CITY MANAGER MEMORANDUM, NOVEMBER 7, 2005

DATE: November 7, 2005
TO: City Council
FROM: City Manager
RE: Call for Review of Tentative Parcel Map #061676 and Hillside Development Permit #4395 for 720 South San Rafael Avenue (725 Hillside Terrace).

ATTACHMENT A
REVISED CONDITIONS OF APPROVAL FOR
HILLSIDE DEVELOPMENT PERMIT #4395

Attachment C
Landscape Plan Showing Tree Canopies

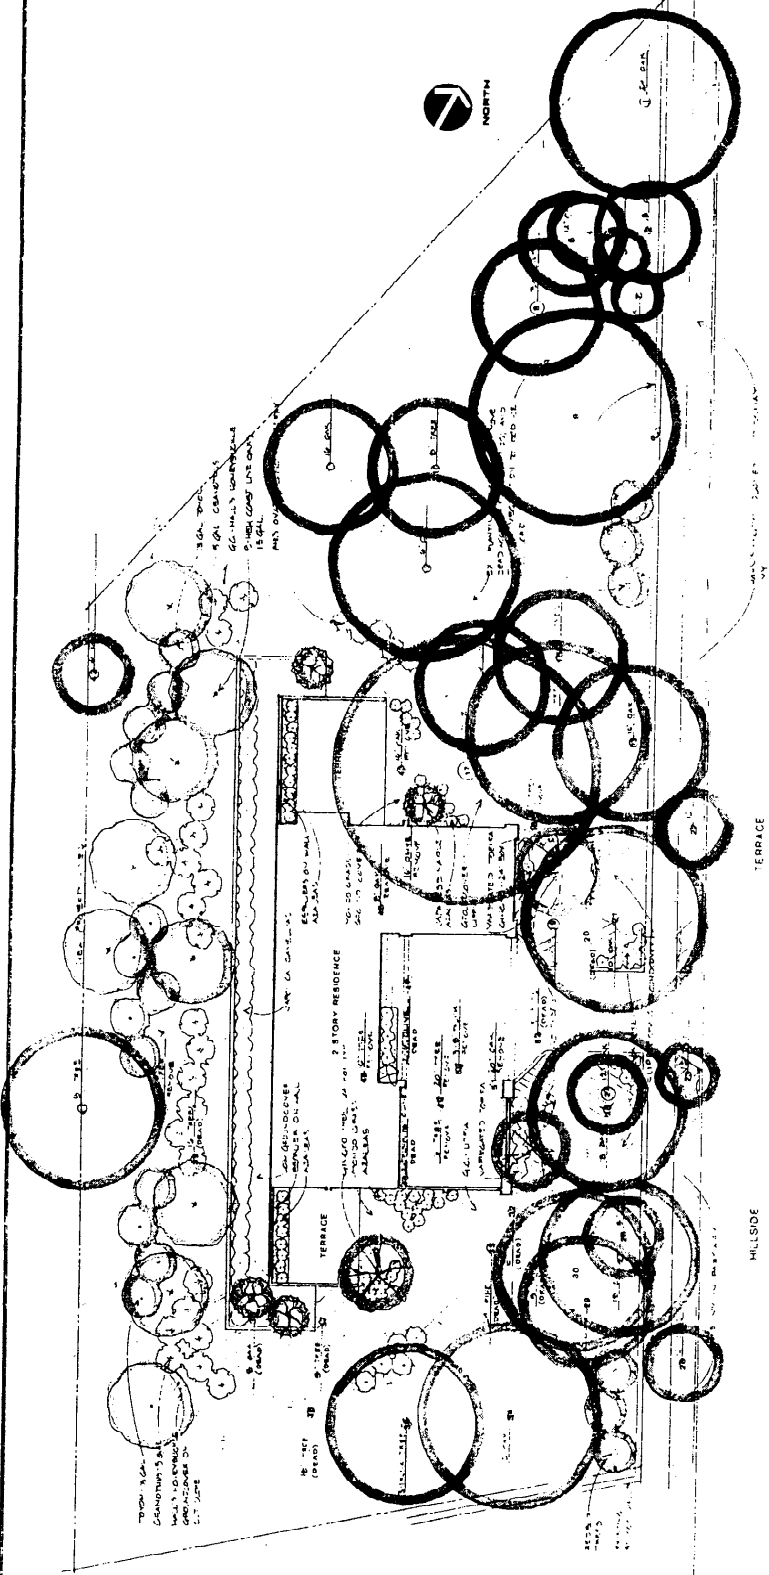
Some of the meeting attendees were concerned that the eleven trees to be planted between the house and the front property line would be inadequate to properly screen the house from the street (Hillside Terrace). In response to this, the architect has submitted a revised landscape plan (Attachment C) that shows the existing and proposed tree canopies. This plan shows a high amount of tree foliage throughout the property, particularly between the house and the Hillside Terrace.

**Attachment D
Section Drawing of Hillside**

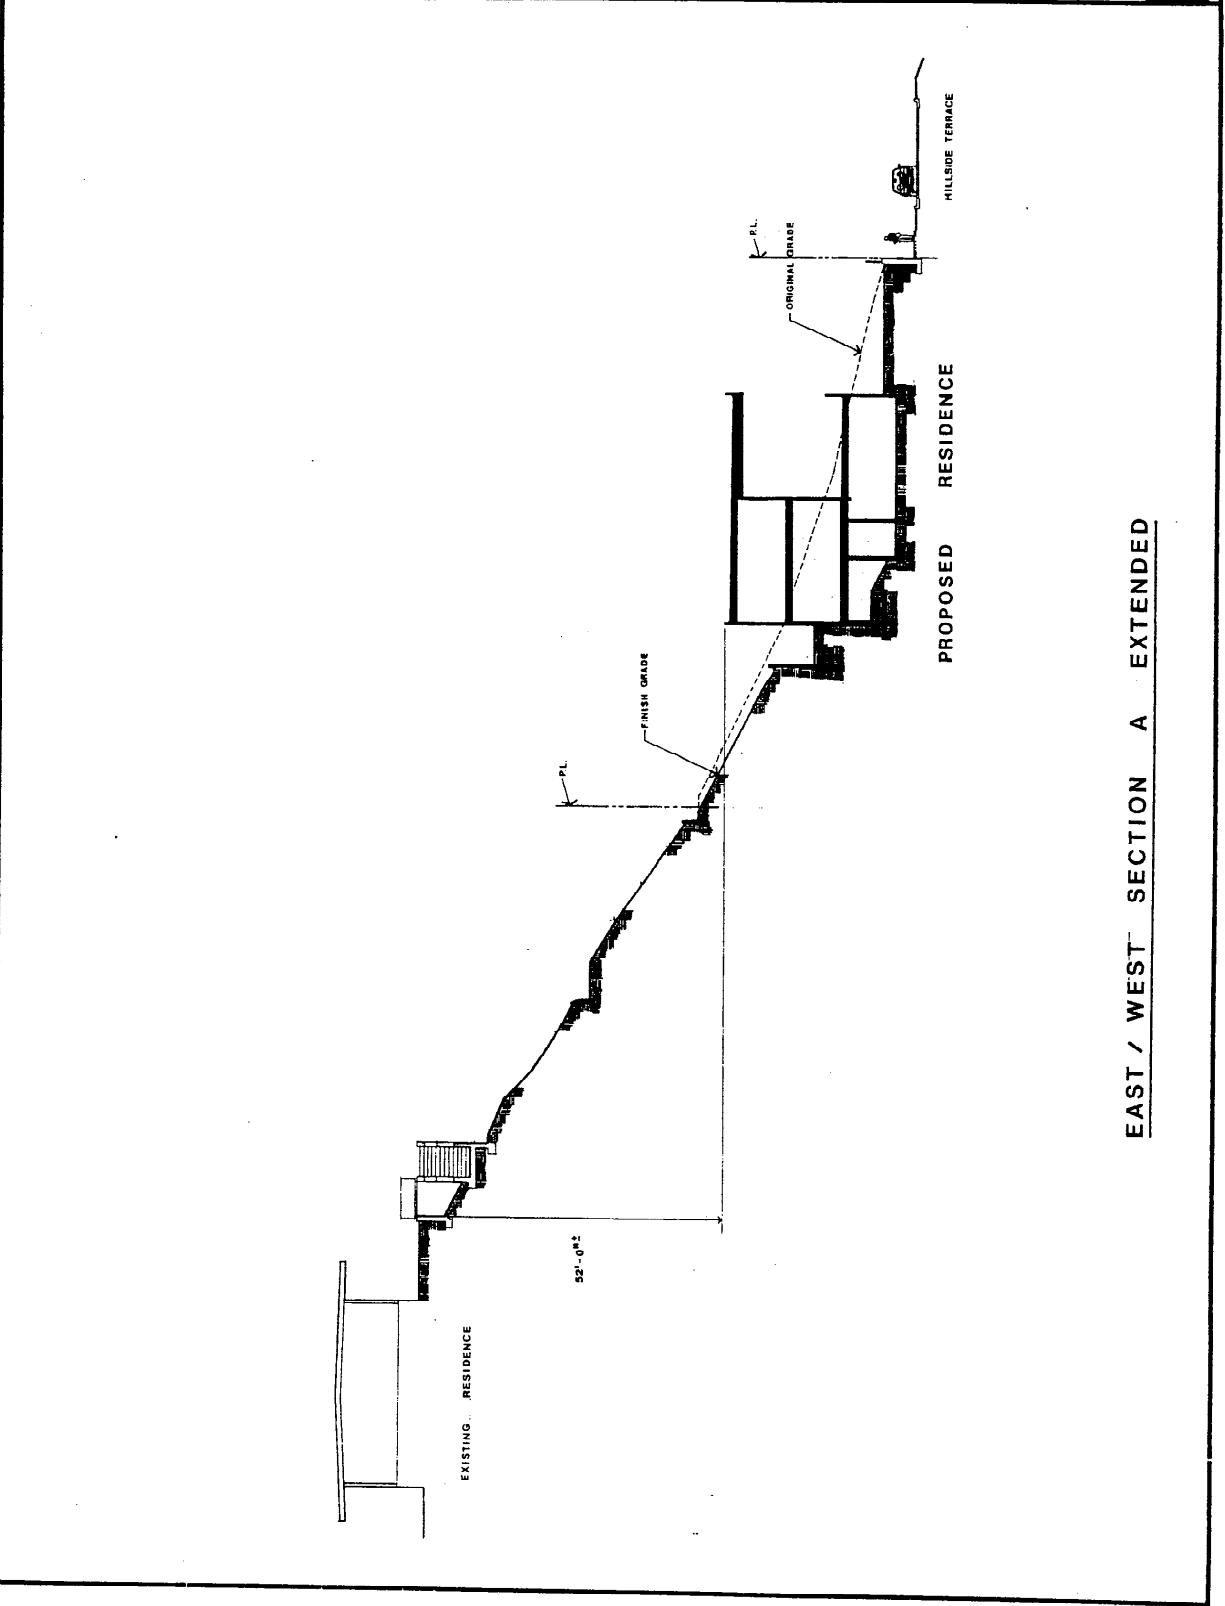
Another option that was proposed by the residents to address the massing of the house is to redesign the house such that it would 'step' up the hillside. The effect of having to significantly redesign the interior of the house aside, the project architect has analyzed the effect on grading and excavation if the front half of the upper floor were moved to the rear of the upper floor. The result is that the rear of the house would be located approximately 16 feet from the proposed rear property line, closer than the 25 foot minimum. There is some flexibility here because the rear property line is proposed through the Tentative Parcel Map application under consideration.

The increase in the amount of hillside that would need to be excavated would be approximately 545 cubic yards; an increase of approximately 25%. It is staff's position that the effect of moving a portion of the house to the rear would unnecessarily increase the amount of grading and excavation on the site.
